Access Compliance Report

Public Rights-of-Way (Curb Ramps)

Intersection ID: 5714	Main Street: JOHN_KIRK_DR	Cross Street: UNIVERSITY_CITY_BV	Location:	W
ADA ID: 1ED970B0581F	Ramp Type: Directional1	Initial Pass/Fail: Pass	Overall Compliance: No	Severity Score: 10

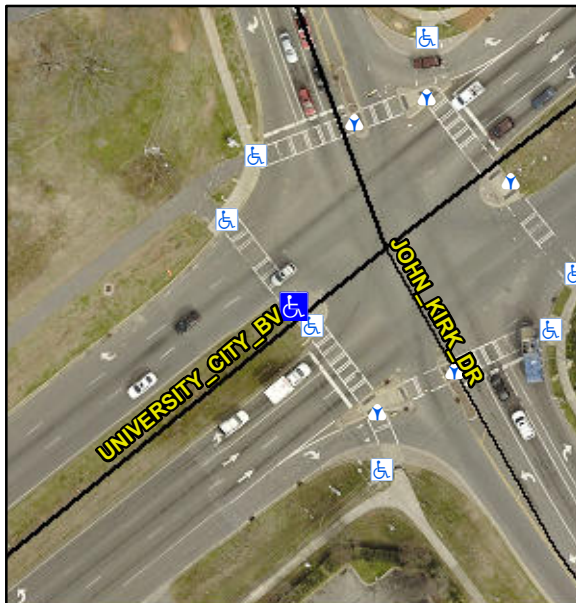
RP < 5%

**R304.2.3, R305.2, R302.7, R304.5.4,
R304.5.3**

**Remove & Replace Entire Ramp.
Remove & Replace Gutter.**
